Evaluation and Compilation of DOE Waste Package Test Data

Biannual Report: February 1987 - July 1987

U.S. Department of Commerce
National Bureau of Standards

Prepared for
U.S. Nuclear Regulatory
Commission

Figure 2. Normalized Si Release [Chick 1984] predicted by cubic model from 101 data points (TOP) and quadratic model from 76 data points (BOTTOM).

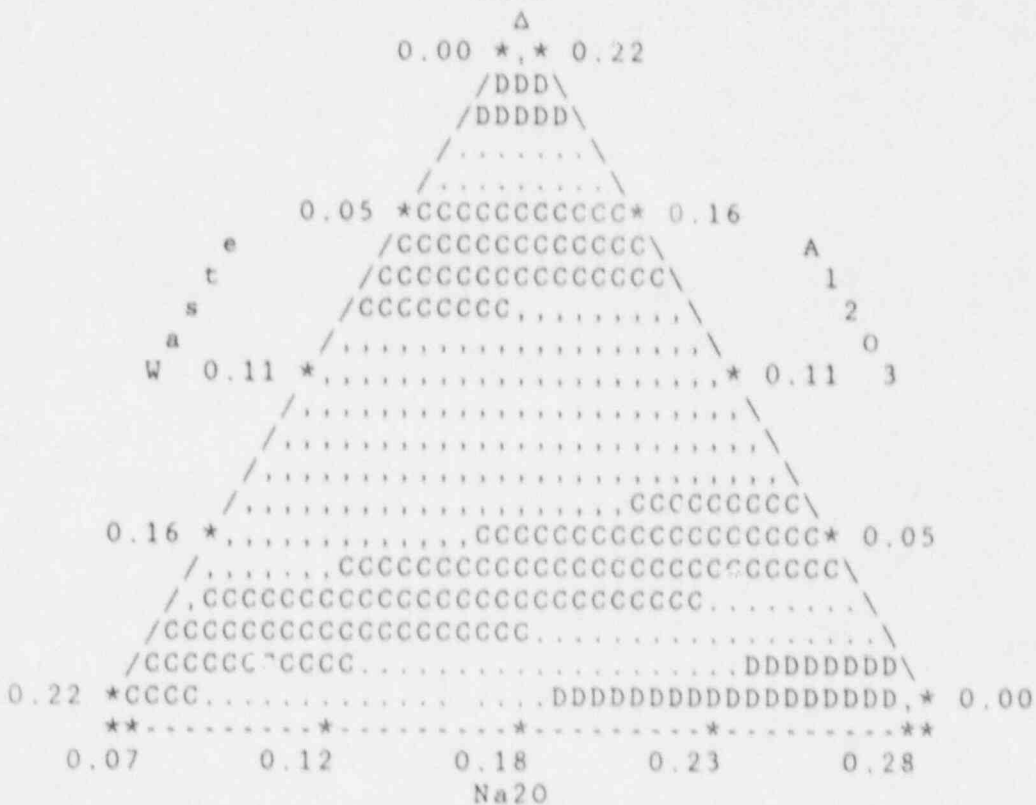
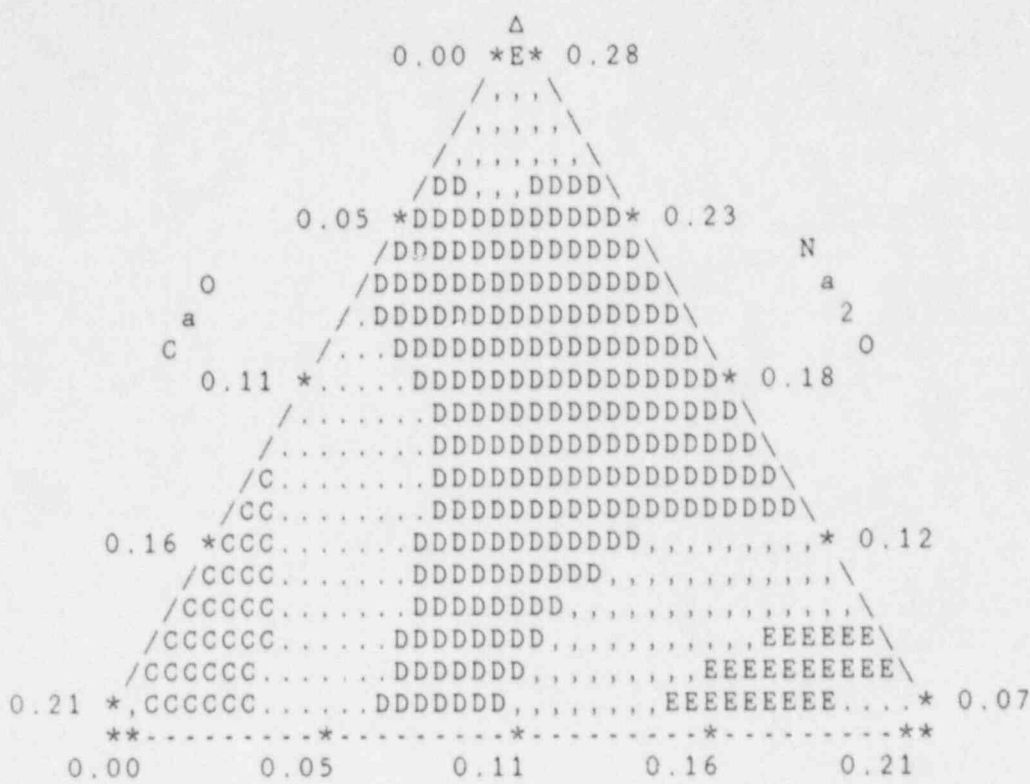
Our comparison of the two models is based on the contour plots shown in Figures 2-5. Before discussing the comparison, we consider the interpretation of these plots. Consider the top plot in Figure 2. This plot shows the logarithm of the normalized Si release for the 28-day MCC-1 test run at 90°C with deionized water as the leachant. The normalized Si release is shown as a function of the seven components that make up the glass [Chick 1984]. Of the seven components, three are allowed to vary in each of these contour plots and the other four are held constant at the proportions for the glass recommended as optimum in the study, SiO_2 0.454, B_2O_3 0.024, Na_2O 0.155, CaO 0.102, Al_2O_3 0.009, Fe_2O_3 0.135, and Waste 0.121. The level of the response is shown by the letters, periods, and commas, and a scale for these symbols is shown on the right of the plot. Each symbol represents an interval in the response. This interval begins at the value shown next to the symbol and ends at the higher value one step along on the scale. Note that the B's in the middle of the plot indicate a minimum in the Si release. In the plot on top of Figure 2, the response is shown as a function of Al_2O_3 , Na_2O , and Waste. The sum of these three components must be 0.285, as the other four components are fixed. The component Al_2O_3 is constant along horizontal lines, lines parallel to the base of the triangle. The component Na_2O is constant along lines parallel to the left side of the triangle. The component Waste is constant along lines parallel to the right side of the triangle. The minimum shown by the B's is near the proportions Al_2O_3 0.09, Na_2O 0.155, and Waste 0.04. Thus, this Figure suggests that better leach performance can be obtained by substituting Al_2O_3 for Waste.

The two contour plots in Figure 2 contrast the original cubic model shown on the top with the alternative quadratic model shown on the bottom. The two plots are generally similar. However, the quadratic model does not show a distinct minimum in the middle as the cubic model does. Rather, the quadratic model suggests that better leach performance can be obtained

Figure 3. Normalized Si Release [Chick 1984] predicted by cubic model from 101 data points (TOP) and quadratic model from 76 data points (BOTTOM).

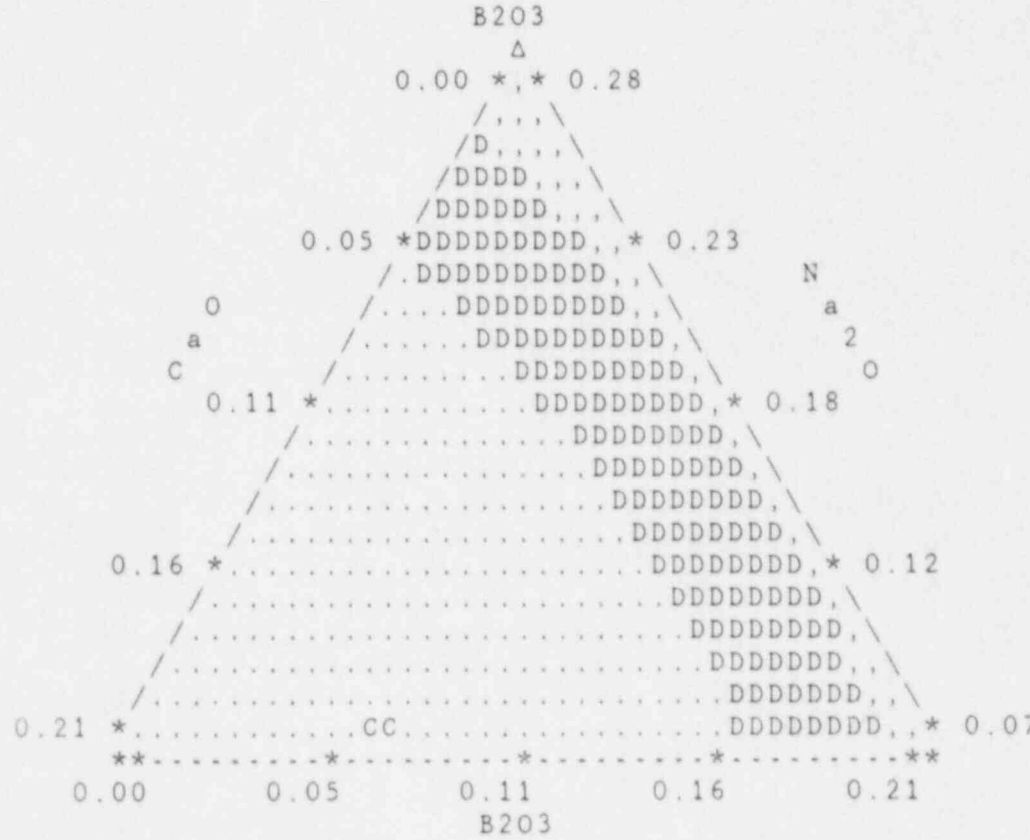
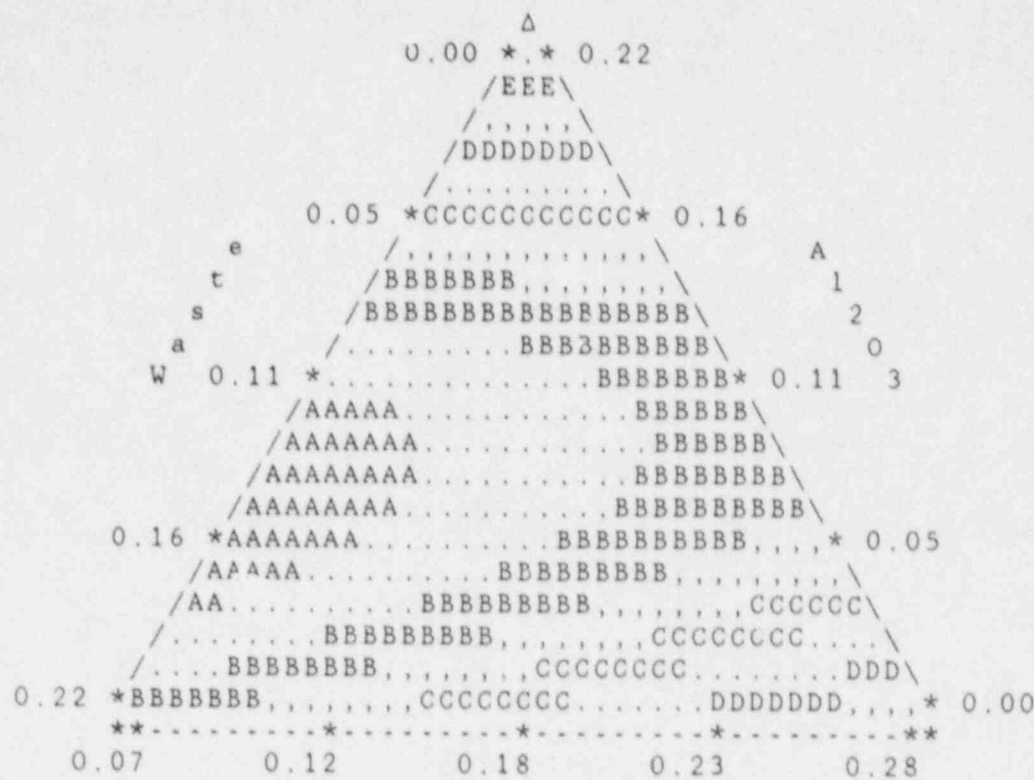
Figure 3 also contrasts the cubic and quadratic models but in terms of a different perspective on the response surface. The study by Chick, et al. discusses the fact that better leach performance can be obtained with more CaO and less B_2O_3 than has been recommended in previous studies [Chick 1984]. While this conclusion seems generally to hold for both models, the change in leach behavior is more gradual under the quadratic model. Moreover, the quadratic model shows a minimum at the lowest level of Na_2O for B_2O_3 near 0.06.

Figure 4. Normalized Waste Release [Chick 1984] predicted by quadratic model from 76 data points.

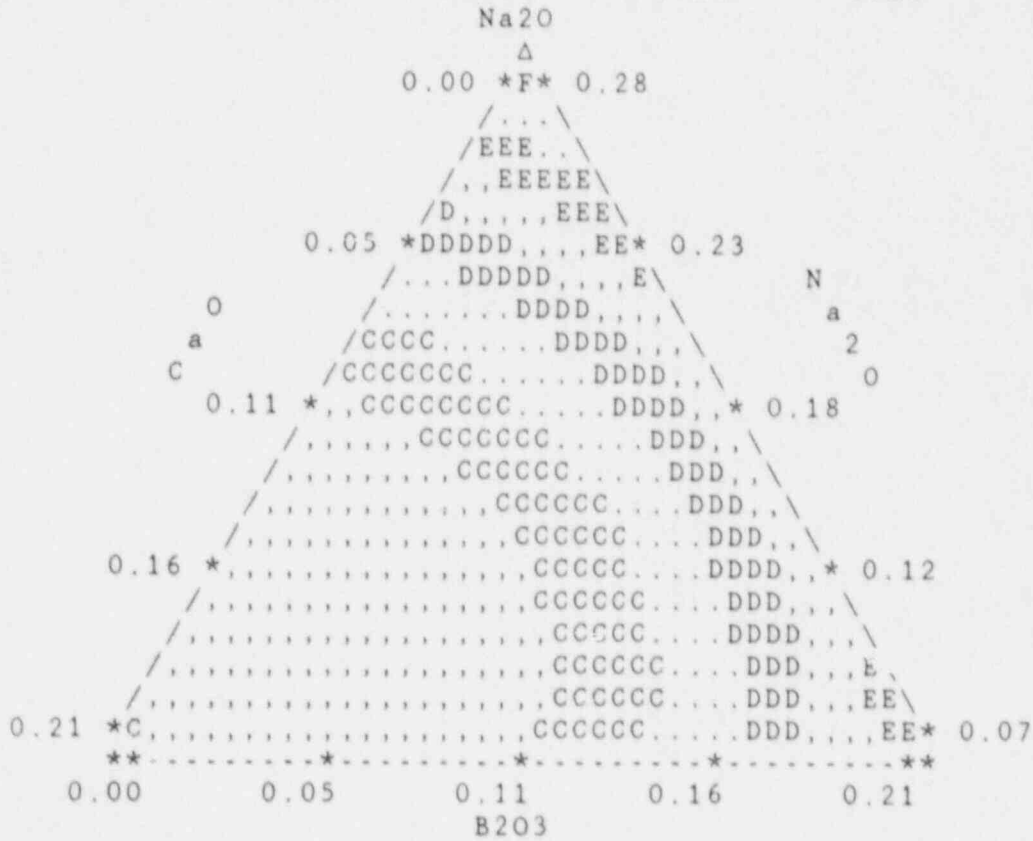
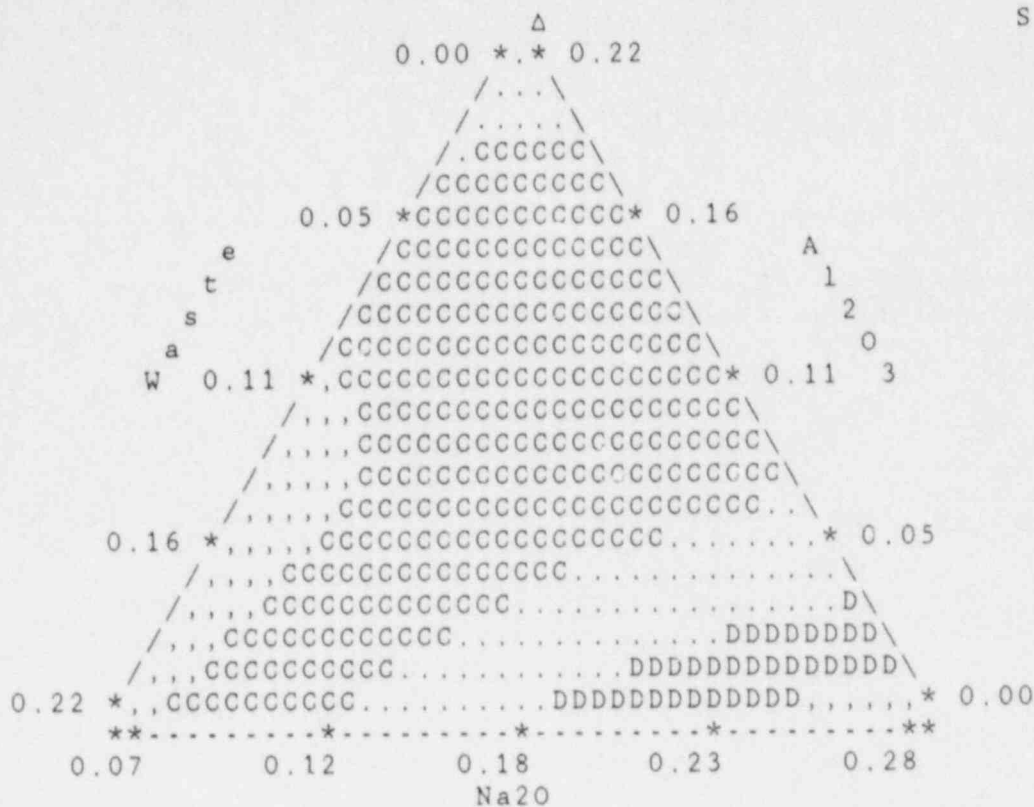
Figure 4 shows the quadratic model obtained for another leach component, the logarithm of the normalized Waste from the 28-day MCC-1 test. The top plot shows the components that are shown in Figure 2, and the bottom plot shows the components that are shown Figure 3. The top plot shows distinctly that better leach performance can be obtained by substituting Al_2O_3 for Na_2O while holding the Waste constant. The bottom plot supports the assertion in the original study that better performance is obtained with higher CaO and correspondingly lower B_2O_3 .

Figure 5. Composite Leach Response [Chick 1984] predicted by quadratic model from 76 data points.

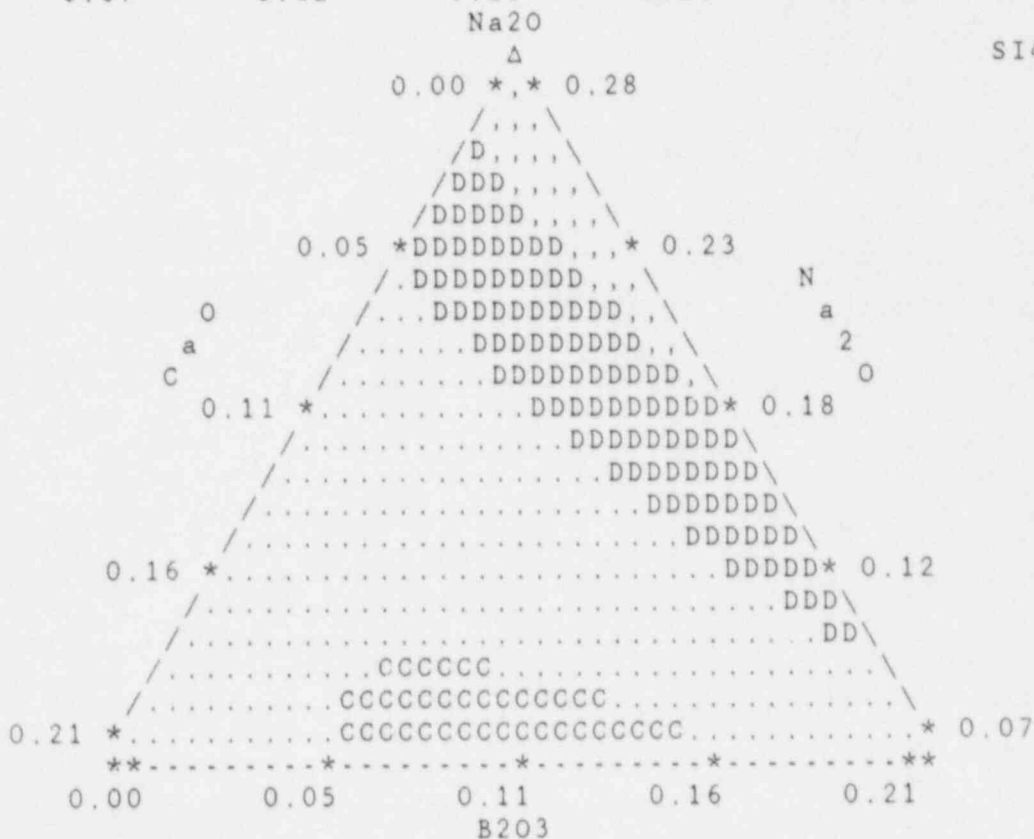
Figure 5 shows the quadratic model obtained from the composite leach response used in the original study to judge leach performance. This composite response is calculated from responses from five of the seven leaching tests performed. Again the top plot corresponds to Figure 2, and the bottom to Figure 3. The top plot shows better leach performance is obtained with more Al_2O_3 and less Na_2O . The bottom plot suggests that for low levels of Na_2O , the substitution of CaO for B_2O_3 can be carried too far.
